Technical Memorandum 8-60

HUMAN FACTORS ENGINEERING EVALUATION  
OF THE  
M60 MAIN BATTLE TANK

Kermit D. Foster

June 1960

Fig. 1. Octave band measurements of the noise in the turret of the M60 Tank at 30 mph and 10 mph

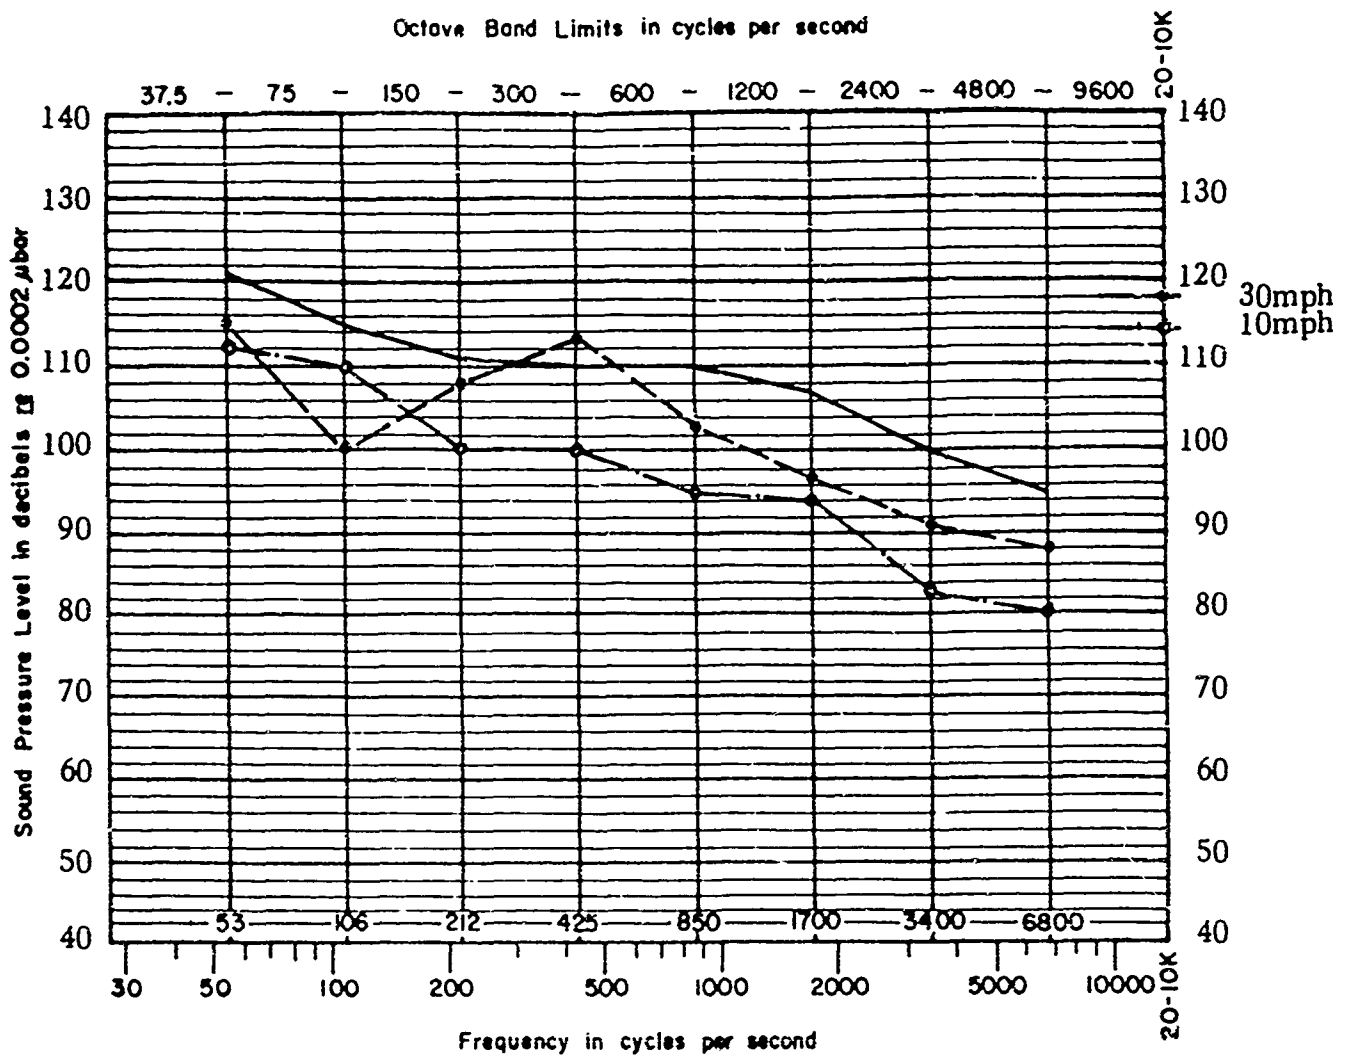
An octave band analysis of noise in the turret at speeds of 30 mph (high range) and 10 mph (low range) was also conducted. At 500 cycles per second, the sound pressure level exceeds the Human Engineering Laboratories' maximum sound pressure level standard for that octave band by 3 db. This deviation from the recommended limit is negligible and no action, in terms of additional sound attenuation, is recommended.
